In re Application of)
)
PANUNTO, John P.)
)
Serial No: 10/660,533) Art Unit: 3653
)
Filed: 09/12/2003) Examiner: **MORRISON, Thomas A.**

For: **LARGE CAPACITY BOTTOM FEED DISPENSER**

RESPONSE TO OFFICE ACTION DATED 01/03/2006

Fig. 3

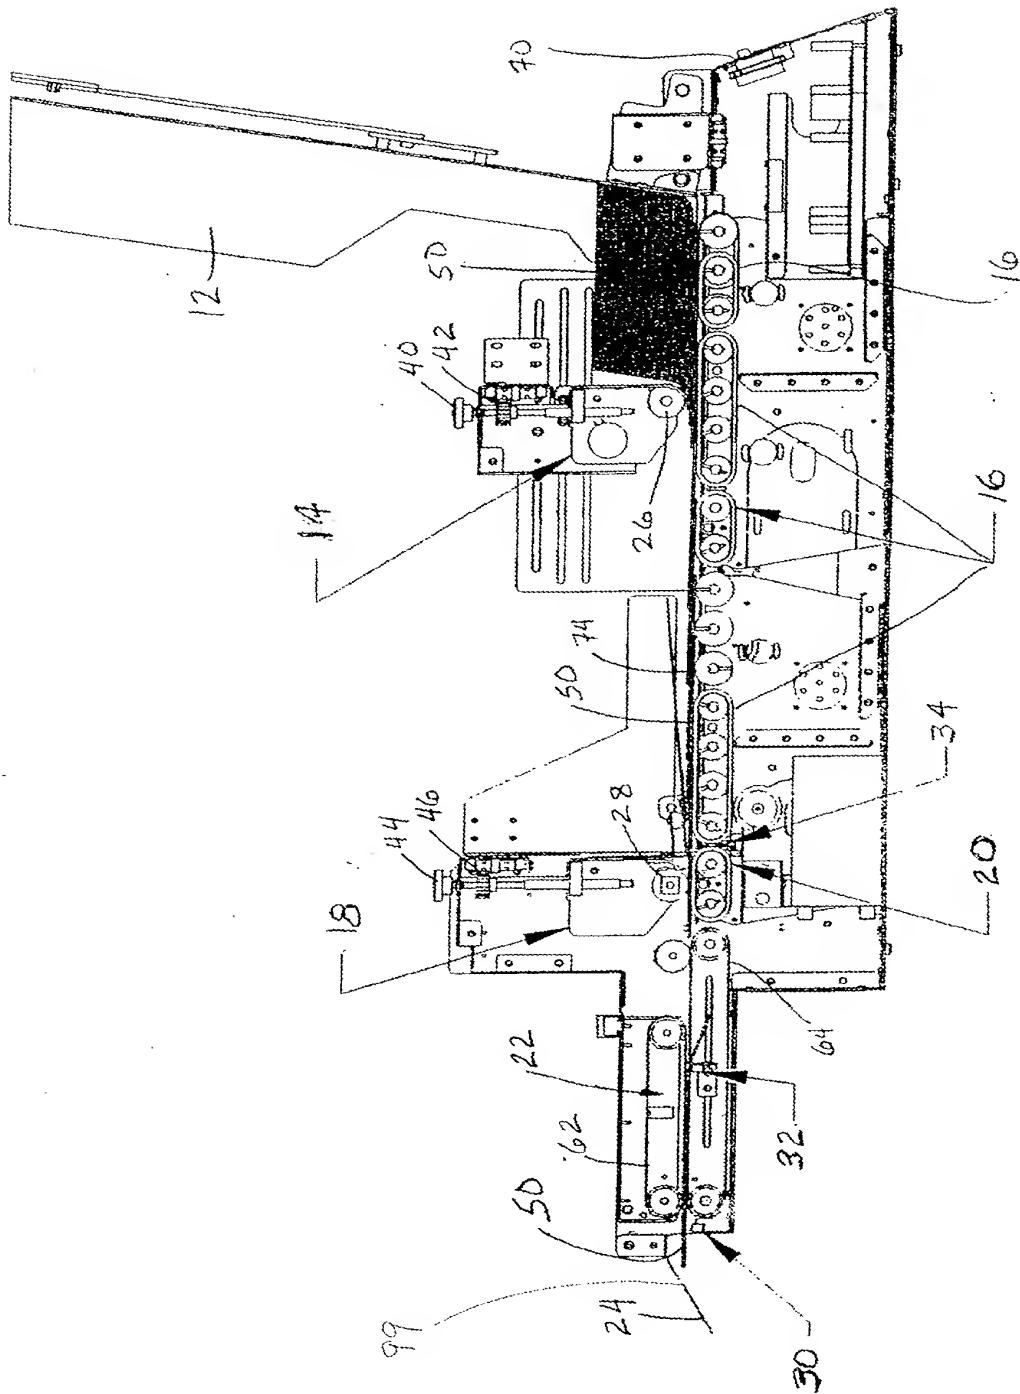
The drawings were objected to because of the reasons set forth in section 1 of the Office Action. In response, Figure 3 has been amended to remove reference character 22 pointing to the axle of the transport conveyor. Figure 3 has also been amended to label the location of the box ready sensor 99. In a related amendment, paragraph [0054] has been amended to identify the “box ready sensor” as --box ready sensor 99--. In view of these amendments, it is respectfully submitted that the drawings are now in proper form, and withdrawal of the objection to the drawings is requested.

The attached sheet of drawings includes changes to Figure 3. This sheet replaces original Figure 3.
